Appendix E: Complex freshwater fisheries activity approval report

Section 51(2)(e) complex freshwater fisheries activity approval report
for – FT-0063 Waihi North Project

Department of
Conservation
Te Papa Atawhai

WAIHI NORTH PROJECT - PROPOSED FRESHWATER FISHERIES DISPENSATION CONDITIONS

Appendix 1: Indicative Stream Channel Diversion Design

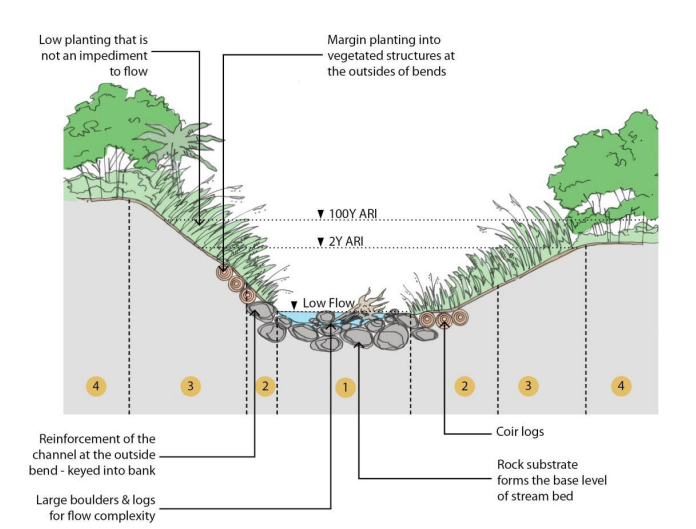
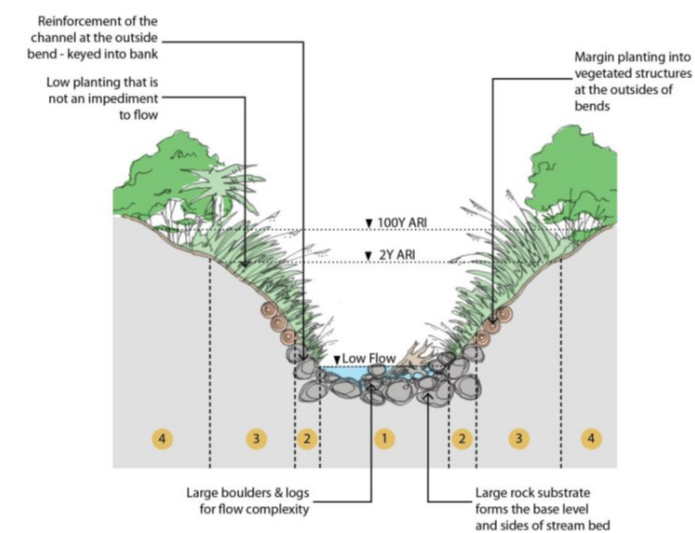
36. An indicative channel design and objectives are provided.⁸ In principle, these could provide appropriate stream habitat but they only give a general description of the overall design objectives, and two indicative cross sections for the 2,765 m of stream diversion proposed to be created. They have also noted issues with providing fish passage, in particular that *'the stream gradient may make it difficult to maintain fish passage for general fish species'*, and therefore that the design should allow for the passage of migrating eels (for TSF3 and NRS/TB1) and other native fish with climbing abilities (for TSF3) to allow them to access the remaining upstream habitat.⁹ However no description of how fish passage will be facilitated or how fish passage constraints (such as how the steep gradient will be incorporated into the design) have been provided.

40. DOC recommends the following:
- That conditions should include a requirement to follow the best practice design standards as outlined in the NZ Fish Passage Guidelines, in particular setting clear fish passage objectives and performance standards (section 3), incorporating appropriate design standards to provide passage for the target fish species (including sections 4, 5.5.3 and 7.3.5, and Appendix A), and monitoring fish passage success (section 8).

- That the conditions should include the criteria for nature-like fishways (table 7.3 of the NZ Fish Passage Guidelines) to ensure that fish passage objectives are met throughout the diversion channels. Flows through the channel should allow for the life history stages of the applicable fish species. Aspects of the design specifications for rock ramp fishways (table 5.4), culvert design methodology (considering fish swimming ability, e.g. figure 4.8) could be used to aid design.
